ENGINE - HP TURBINE ROTOR AND STATOR ASSEMBLY - INTRODUCE A NEW FIRST STAGE TURBINE AIR SEAL - CATEGORY CODE 6 - MOD.ENG-72-0180

V2500-ENG-72-0180

Before and After view of configuration changes that affect the High Pressure Turbine Rotor and Stator Assembly
Fig.1

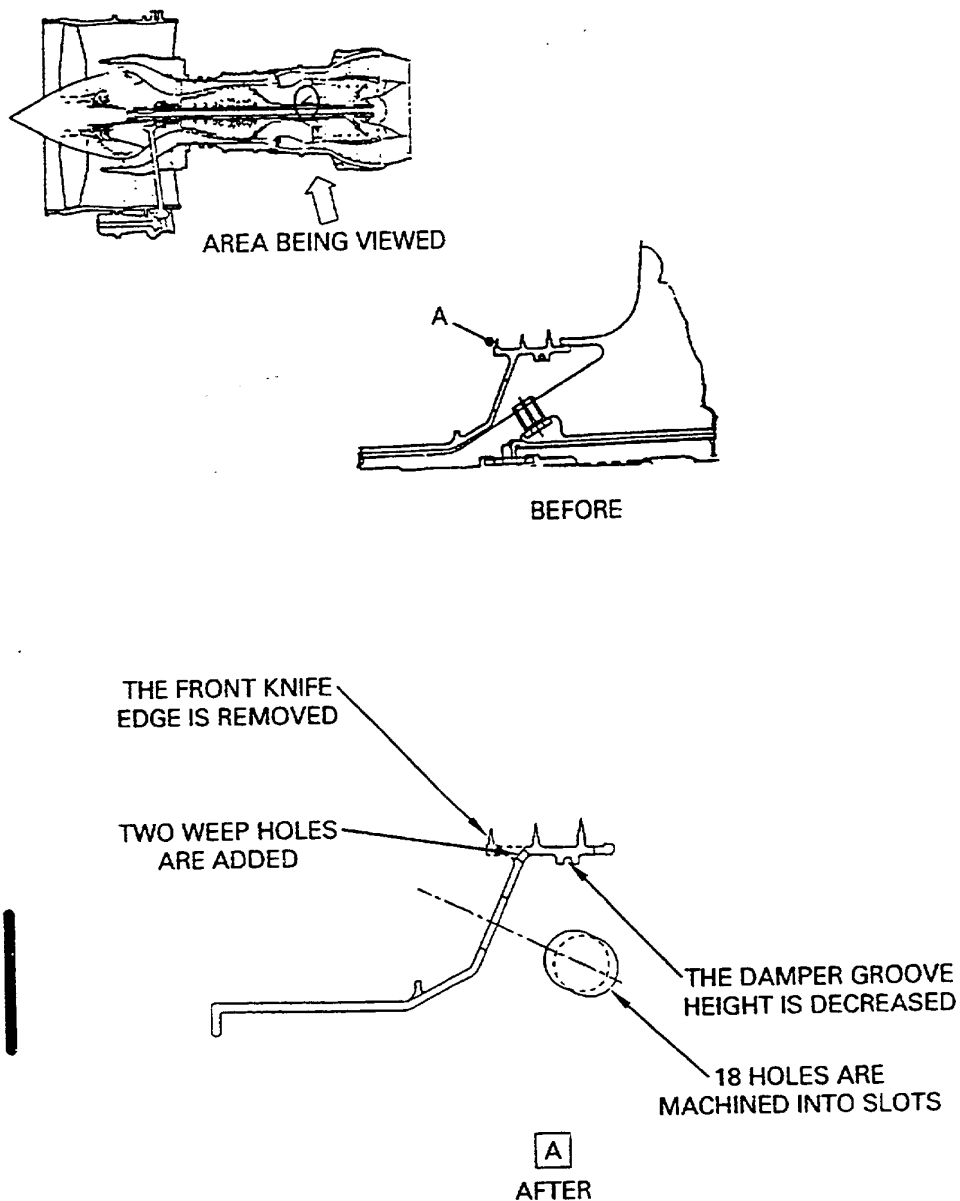
To provide a Stage 1 HPT Air Seal with features that let the unwanted oil drain more quickly. These features include: Removal of the front knife-edge, additional drain holes, an elongated cooling air hole and a damper groove with a decreased wall height.

- (1) Improve the features of the Stage 1 HPT Air Seal so that more of the unwanted oil will drain from the area between the air seal and the Stage 1 Hub.
- (2) For the effect on declared lift, see the Engine Manual, 5-10-01, Group A Parts Lives.

Location of the Stage 1 HPT Air Seal
Fig.2

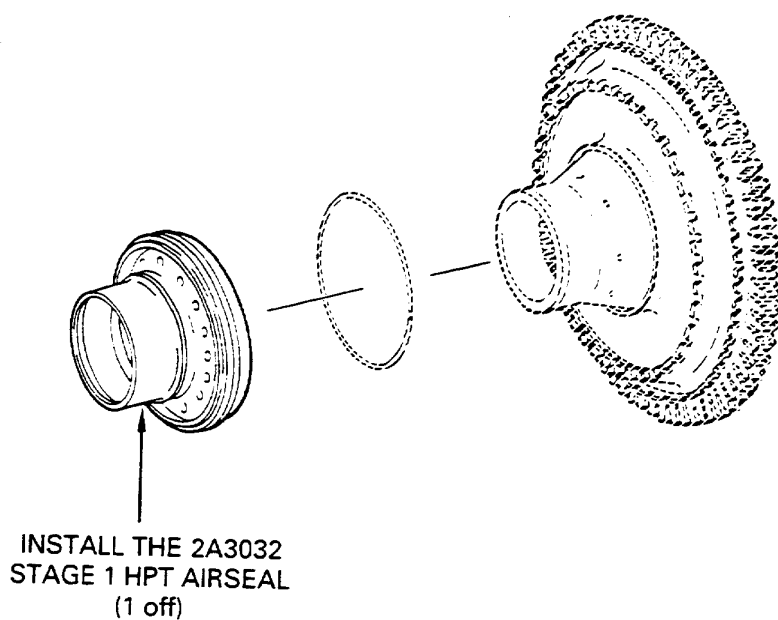
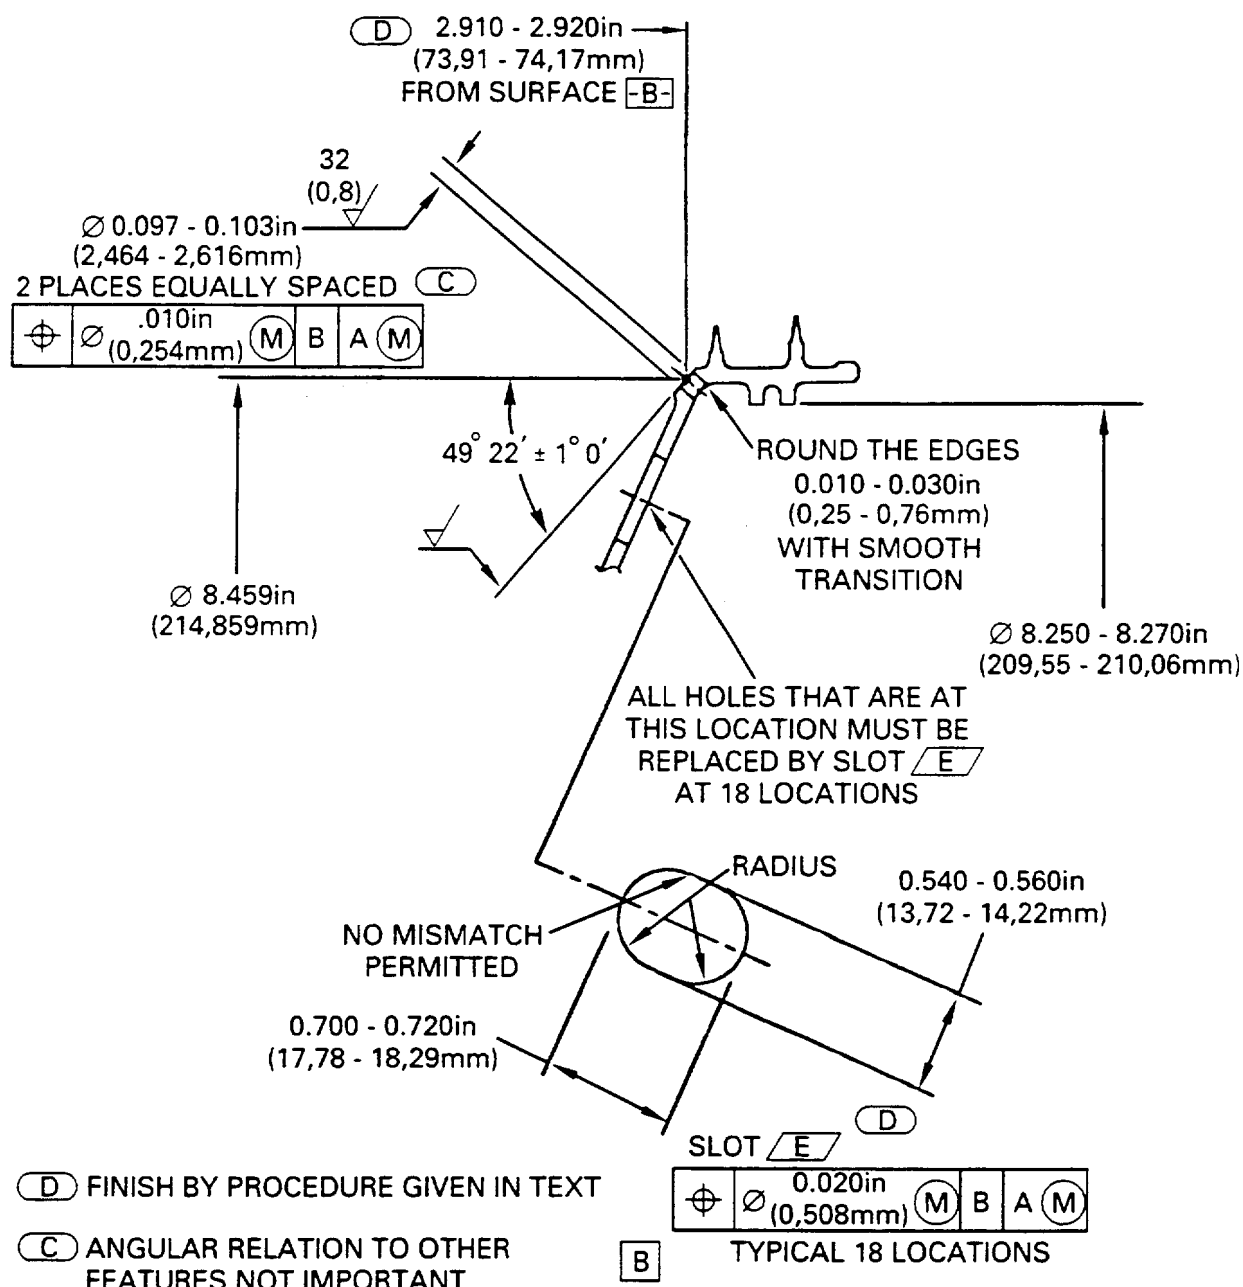
- (1) Install the 2A3032 Stage 1 HPT Air Seal (1 off) by the approved procedure given in References (2) or (3), Chapter/Section 72-45-10 Assembly. See Figure 2.

- (a) Cool the Stage 1 HPT Air Seal in dry ice before you install it.
 - (b) Use the IAE 1P16029 Drift to install the Air Seal.
 - (c) Install the new Air Seal with the balance mark at the same location as the removed Stage 1 HPT Air Seal.
- (2) Identify the new rotor assembly as 2A8721 by the procedure specified in Reference (4), Chapter/Section 70-09-00, Marking of Parts.

Modification of the Stage 1 HPT Air Seal
Fig.3 (Sheet 1)

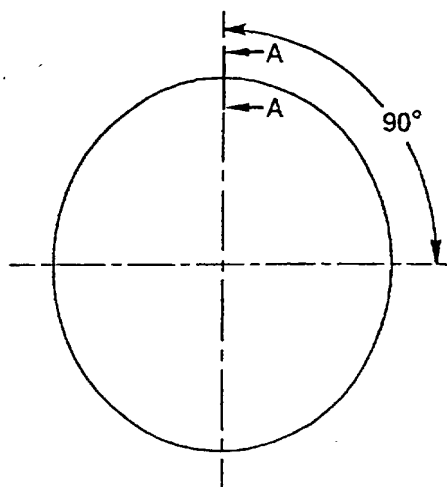
Procedure	Supplementary Information
(a) Set-up and machine to the dimensions specified and as follows:	Refer to Figures 1 and 2.
1 Machine to remove the front knife edge seal.	
2 Machine two holes at the locations and to the dimensions specified.	
3 Machine 18 slots E at the hole locations specified.	
4 Machine the damper groove height to the dimensions specified.	
(b) Do a check of the static unbalance at 900 RPM with the part held on	Refer to Figure 2.

Modification of the Stage 1 HPT Air Seal
Fig.3 (Sheet 2)

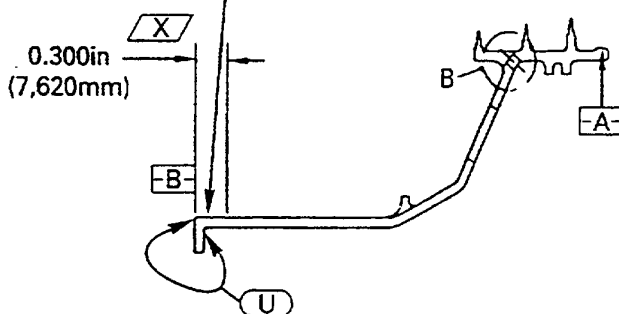
DO A CHECK OF THE BALANCE
AT 900 RPM. MAKE A MARK
AT THE POINT OF MOST
UNBALANCE (Heavy side) WITH THE
SYMBOL Δ IN DISTANCE Δ X
MAKE A RECORD OF THE AMOUNT
OF UNBALANCE IN OZ - IN (gmm)
ADJACENT TO THE SYMBOL Δ
